GoBike Strathclyde Cycle Campaign

DATE: 01/07/2023

Re: QUEENS DRIVE_LANGSIDE ROAD
(TRAFFIC REGULATION) ORDER 202__

Figure 2: Drawing of Queen’s Rd/Langside Rd./ amended by suggestions.

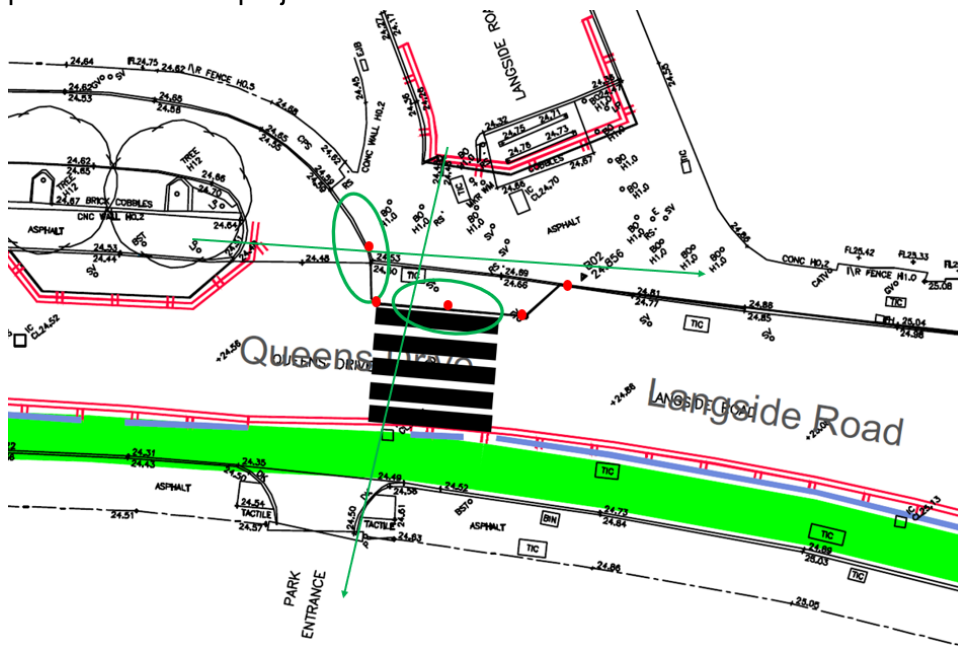
How would this buildout be realized? It would be very important that dropped kerbs are retained here to allow continuous access and crossing for pedestrians, wheelchair users, prams etc. In figure 2, the green arrows indicate desire lines for which dropped kerbs in particular at the locations where the green ellipses are added are needed. Perhaps the black buildout area can simply be realized not with added tarmac, but

instead simply by bollards that surround the space and protect it from parking? In figure 2, potential positions of such bollards are indicated as red dots. We note that the buildout is also a great opportunity to reduce street clutter here. Finally, indicated in the figure 2 is a suggestion for a zebra crossing at this important point, to further support the stated project aims, in particular to “Provide more crossing points across the project area.”

Figure 3: Left: old plans from the “Connecting Battlefield” page <https://storymaps.arcgis.com/stories/81d55a36d6a642a7bc0edeceea8bc6ec> ; right: the now proposed design

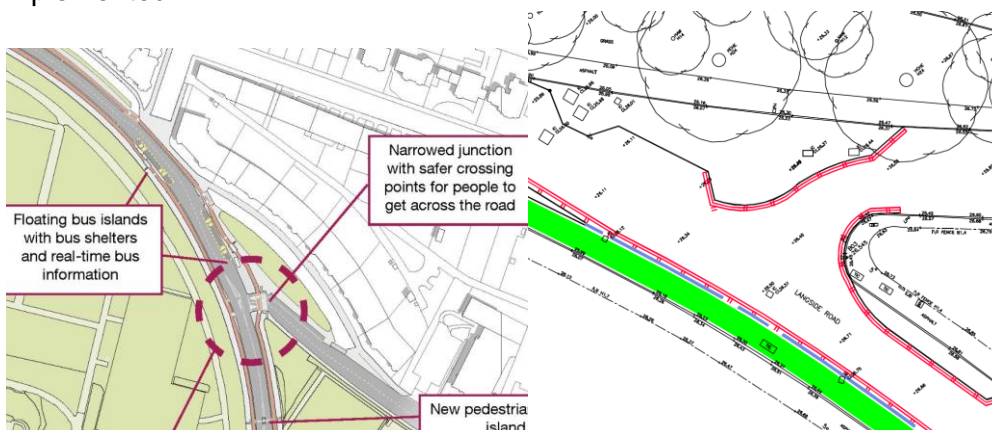
- At Langside Rd./Queens Dr. junction, previous “Connecting Battlefield” designs emphasized that a “safer crossing point” should be established. The current plans merely show a much narrowed road entrance, which is very good, but no details on how crossing will be facilitated to rebalance priority in favour of pedestrians as an overarching project aim and funding condition. What further provisions are foreseen to make pedestrian crossing safer here? Can a continuous raised crossing be implemented?
